B. & J. SUBDIVISION

The plat illustrates the proposed 2-lot, 5.1± acres subdivision which is located at 8361 Silver Pine Road (South side of Silver Pine Road, 250'± West of Maple Valley Road). The subdivision is served by public water and private on-site sewage.

The purpose of this subdivision is to create two legal lots of record from an existing metes and bounds parcel.

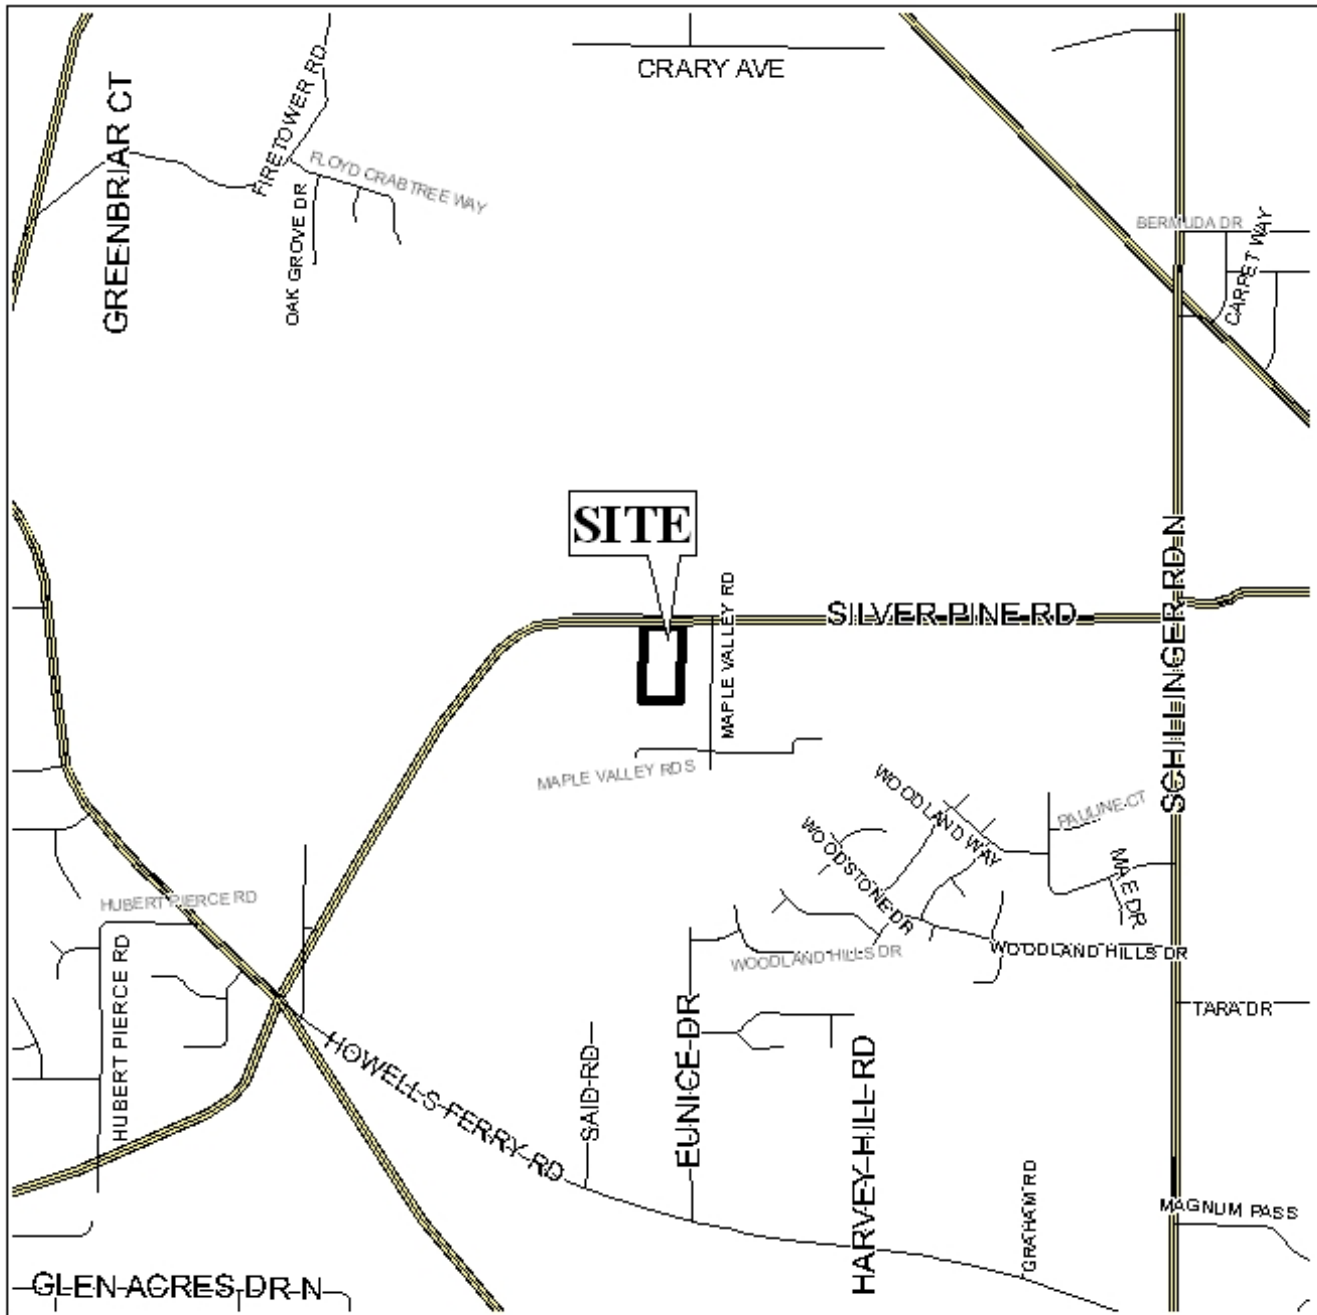
The site fronts Silver Pine Road to the North. Silver Pine Road is a planned major street, and thus, dedication sufficient to provide 50-feet from the centerline of Silver Pine Road should be required. The proposed Lot 1 has 298-feet of public right-of-way frontage, and the proposed Lot 2, a "flag-lot," has 38-feet of public right-of-way frontage.

As there are flag lots and irregularly shaped lots in the vicinity of this proposed subdivision, a waiver of Section V.D.2 of the Subdivision Regulations to allow the "flag-lot" may be appropriate. Otherwise, the lot sizes and dimensions are adequate.

The plat does not illustrate the 25-foot minimum building setbacks, and thus they should be required prior to signing of the final plat.

Given that the proposed Lot 1 is already developed, it should be limited to the existing curb cuts to Silver Pine Road. Because of the limited right-of-way frontage for the proposed Lot 2, it should be limited to one curb cut to Silver Pine Road, with the size, design, and location of all curb cuts to be approved by Mobile County Engineering.

This site is located in the County, thus a note should be placed on the final plat stating that any lots which are developed commercially and adjoin residentially developed property must provide a buffer, in compliance with Section V.A.7. of the Subdivision Regulations.

The site will have to comply with the City of Mobile storm water and flood control ordinances. A note should be placed on the final plat stating that the development will be designed to comply with the storm water detention and drainage facility requirements of the City of Mobile storm water and flood control ordinances, and requiring submission of certification from a licensed engineer certifying that the design complies with the storm water detention and drainage facility requirements of the City of Mobile storm water and flood control ordinances prior to the issuance of any permits. Certification is to be submitted to the Planning Section of Urban Development and County Engineering.

The plat should show the size, in square feet, of each lot, or a table with the same information should be provided.

With a waiver of Section V.D.2 of the Subdivision Regulations, the plat meets the minimum requirements of the Subdivision Regulations and is recommended for Tentative Approval subject to the following conditions:

- 1) dedication sufficient to provide 50-feet from the centerline of Silver Pine Road;
- 2) illustration of the 25-foot minimum building setbacks;
- 3) labeling of each lot with the size, in square feet, or provision of a table with the same information;

- 4) provision of a note on the final plat stating that Lot 1 is limited to the existing curb cuts to Silver Pine Road, and Lot 2 is limited to one curb cut to Silver Pine Road with the size, design, and location of all curb cuts to be approved by Mobile County Engineering;

- 5) provision of a note a note on the final plat stating that any lots which are developed commercially and adjoin residentially developed property must provide a buffer, in compliance with Section V.A.7. of the Subdivision Regulations; and

- 6) provision of a note on the final plat stating that the development will be designed to comply with the storm water detention and drainage facility requirements of the City of Mobile storm water and flood control ordinances, and requiring submission of certification from a licensed engineer certifying that the design complies with the storm water detention and drainage facility requirements of the City of Mobile storm water and flood control ordinances prior to the issuance of any permits. Certification is to be submitted to the Planning Section of Urban Development and County Engineering.
